COMMITTEE REPORT

BY THE EXECUTIVE DIRECTOR OF ECONOMIC GROWTH AND NEIGHBOURHOOD SERVICES
READING BOROUGH COUNCIL
PLANNING APPLICATIONS COMMITTEE: 20th JULY 2022

App No.: 220761 (South Oxfordshire Reference: P22/S1691/FUL)

Proposal: Change of use of an established lake for recreation and sports purposes

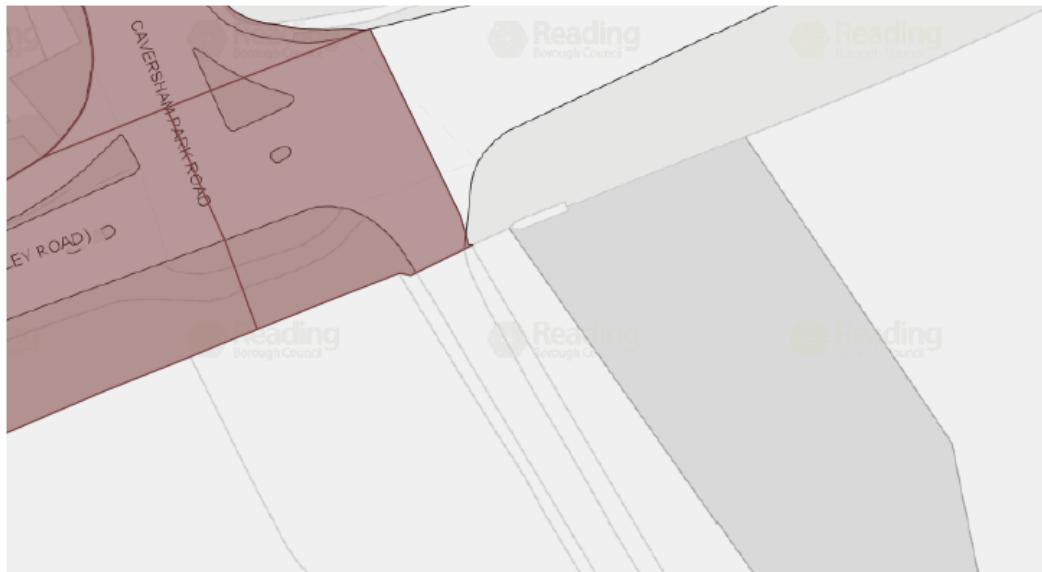
The proposal includes a pedestrian route through the provision of an informal pedestrian route along the Access Road. The pedestrian route would run between the site and the northern end of the Access Road. Some of said route has already been completed with further works still to be undertaken.

To further support the pedestrian route, warning signs will be implemented along the access road to warn drivers of the potential for there to be pedestrians walking along the route.

In addition to the above, a pedestrian route has been included between the on-carriageway facility and the dedicated footway along Henley Road to ensure a complete connection. This provision consists of a 1.8m wide footway to be provided alongside tactile paving and dropped kerbs, this is accepted by the Highway Authority but would require the provision of a S278 Agreement given that the grass verge in question is adopted Highway within Reading Borough. Please see the extract below and the Highway Extent plan attached.

In addition to the facilities to support pedestrian movements, speed cushions are to be introduced along the Access Road, between Henley Road and the site. Speed cushions will be placed at 70m intervals, in accordance with the guidance contained within LTN 1/072. It is accepted that the presence of speed cushions will ensure that vehicle speeds are kept low, and therefore pedestrian and cycle safety will be improved, however, as illustrated on Drawing 2011-019 PL02A the speed cushions are located within the pedestrian route and therefore this would create difficulty for pedestrians especially those with buggies etc. Although the detail of this is located within the South Oxfordshire authority boundary, the design not promote the use of alternative modes and therefore the Reading Borough Highway Authority request that the proposed traffic calming is revised to accommodate the pedestrian movements.

It is noted that the proposal does not include the provision of lighting along the footway and this has previously been of concern given that events during winter months have been advertised on the Caversham Lakes website including weddings, parties and other events such as Oktoberfest Beer Festival, Halloween Fright Night, Fireworks Night and Christmas parties. Current events being advertised include swim by moonlight and summer solstice. All of these events could result in pedestrian movements in the dark leading to potential conflict, however this would need to be further assessed by South Oxfordshire as this section of the access road is within their authority boundary.
